GEORGETOWN-SCOTT COUNTY PLANNING COMMISSION

AGENDA

January 11, 2018

PRELIMINARY DEVELOPMENT PLAN

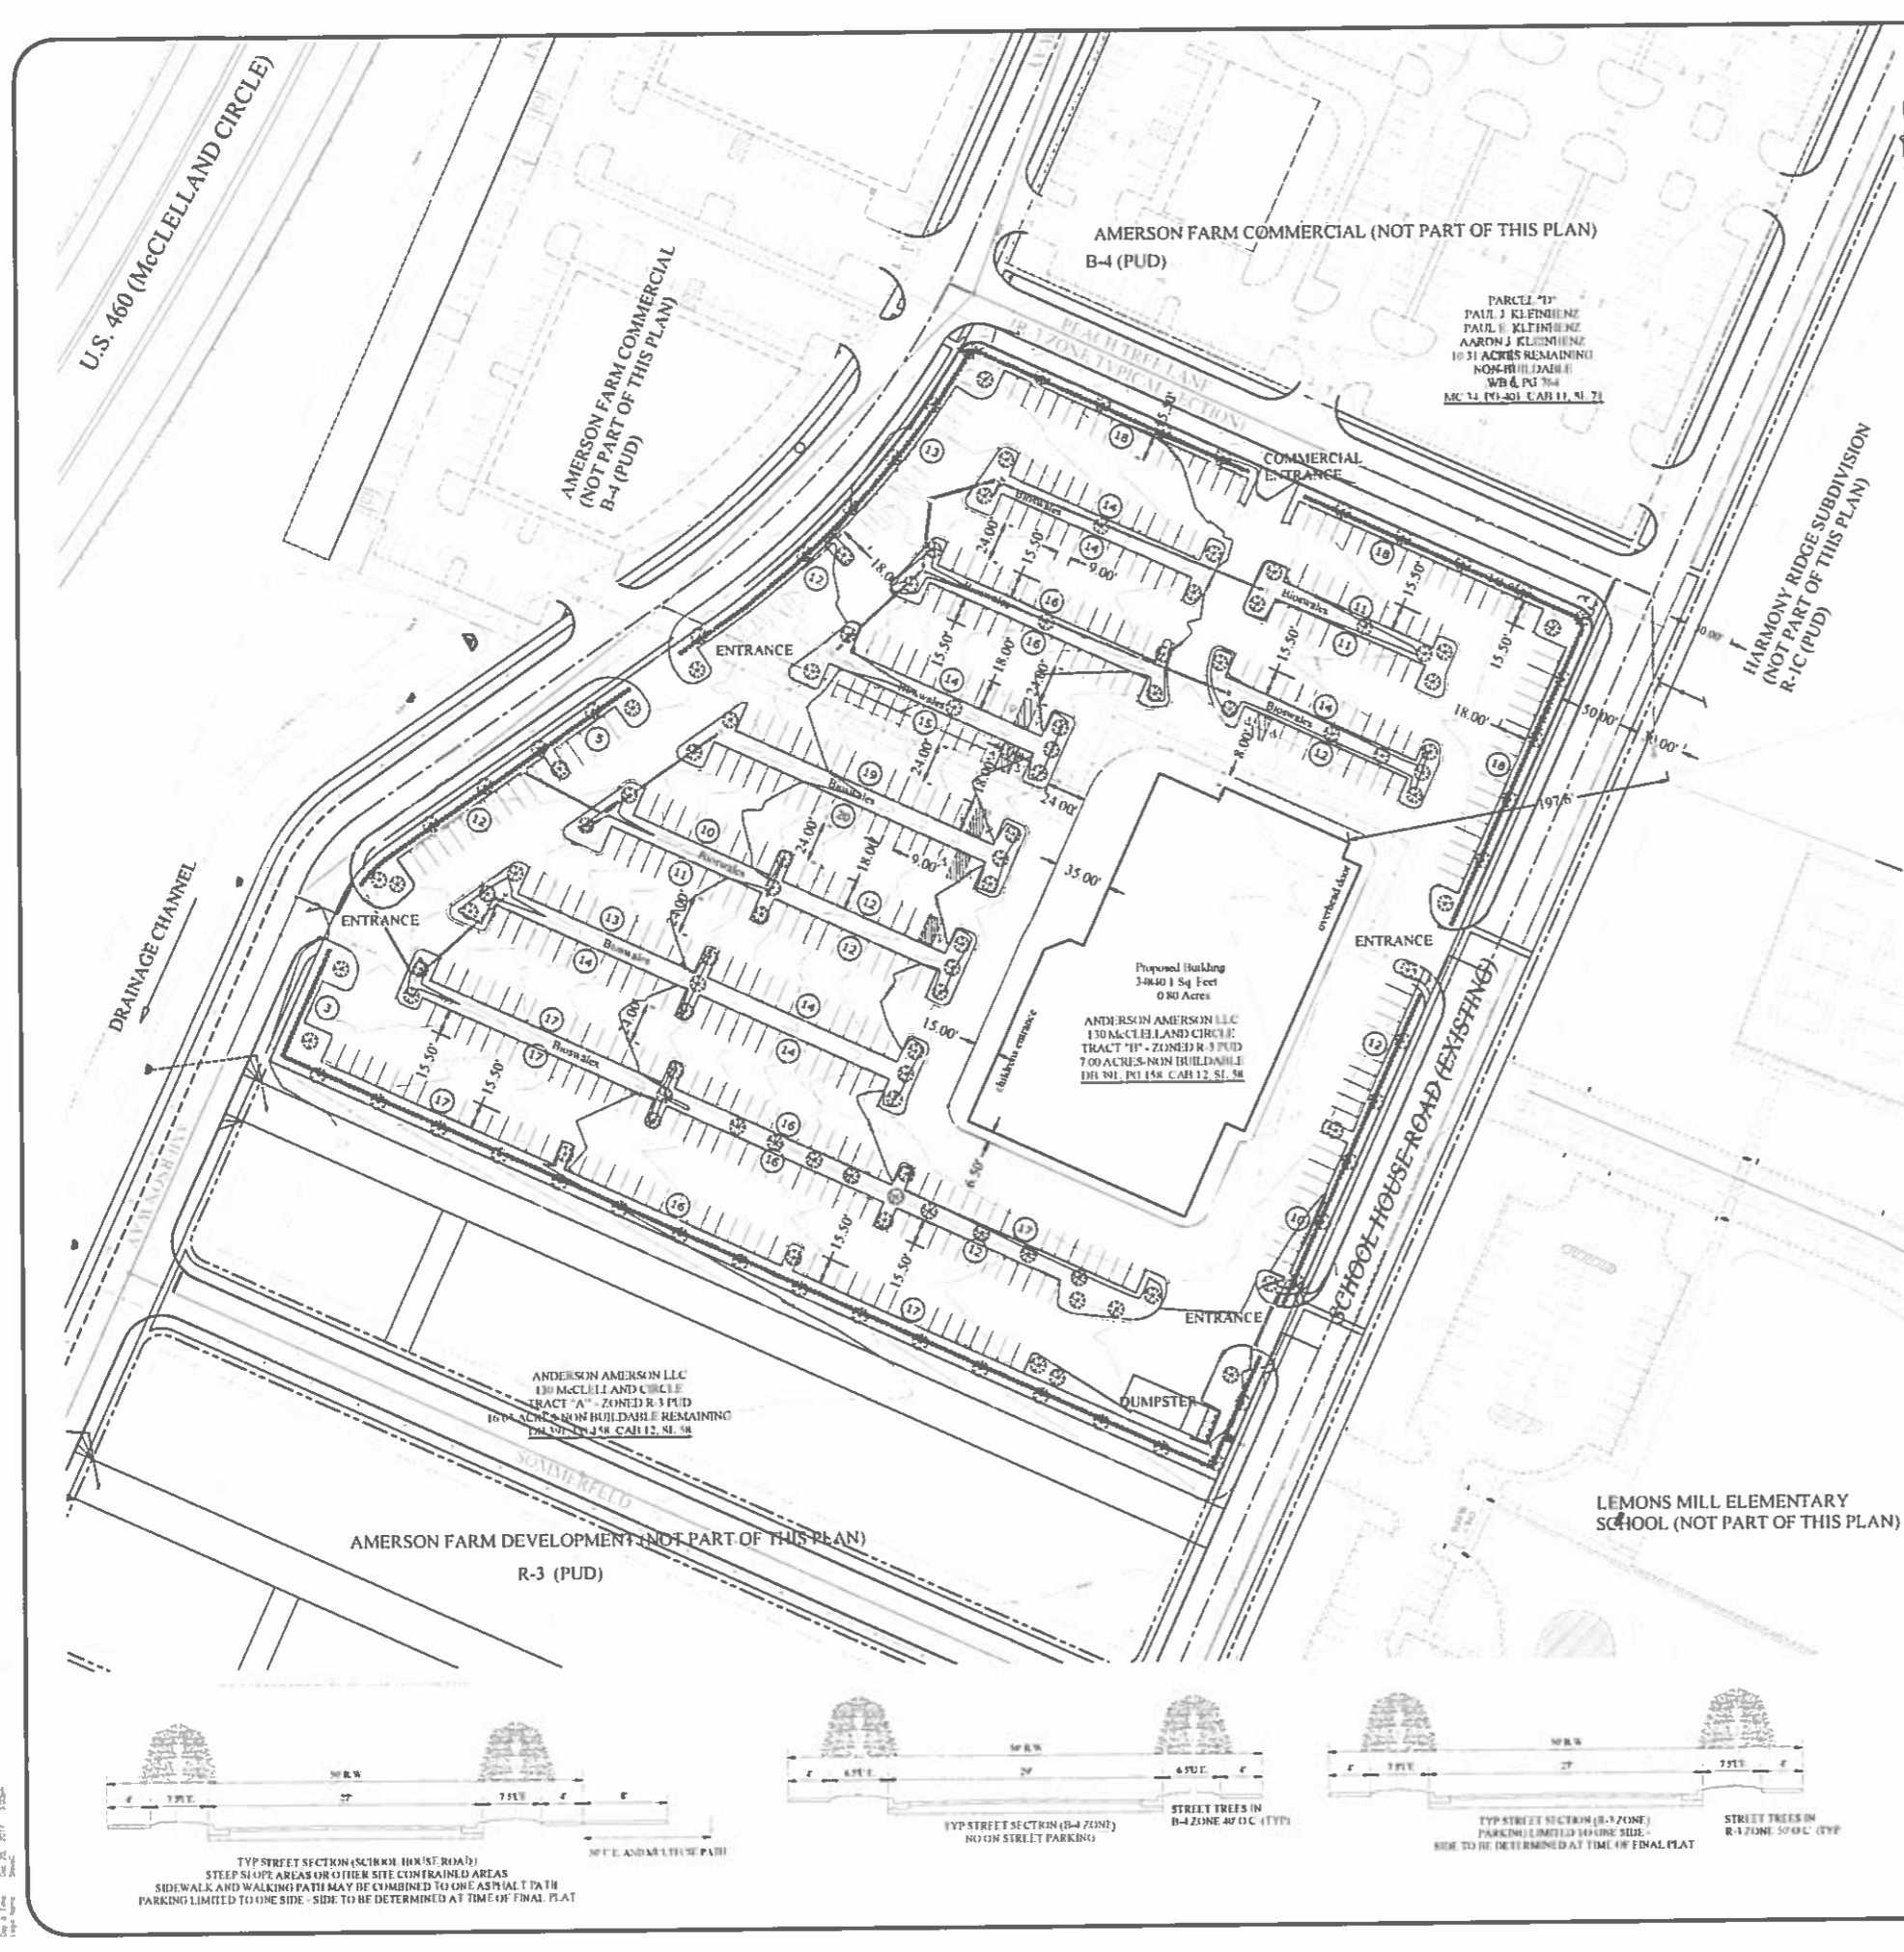
The preliminary landscaping plan shows the appropriate VUA perimeter screening. Tree species were not specified and will have to be provided for the Final Development Plan.

Lighting: A photometric plan will need to be submitted and reviewed as part of the Final Development Plan review. Staff recommends that all exterior lighting should be designed to minimize off-site impacts.

1. All applicable requirements of the *Zoning Ordinance* and *Subdivision & Development Regulations*.
2. A Final Stormwater Management Plan must be submitted and approved by the Planning Commission Engineer prior to approval of the Final Development Plan. Development must meet all requirements of the Georgetown Stormwater Manual.

5. A final specie-specific landscape plan shall be provided along with the Final Development Plan.
6. This Preliminary Development Plan approval is valid for two years, subject to the requirements of Article 406 section A of the Subdivision and Development Regulations.

7. Prior to Final Development Plan Approval either Peach Tree Lane or Amerson Way must be completed and platted.
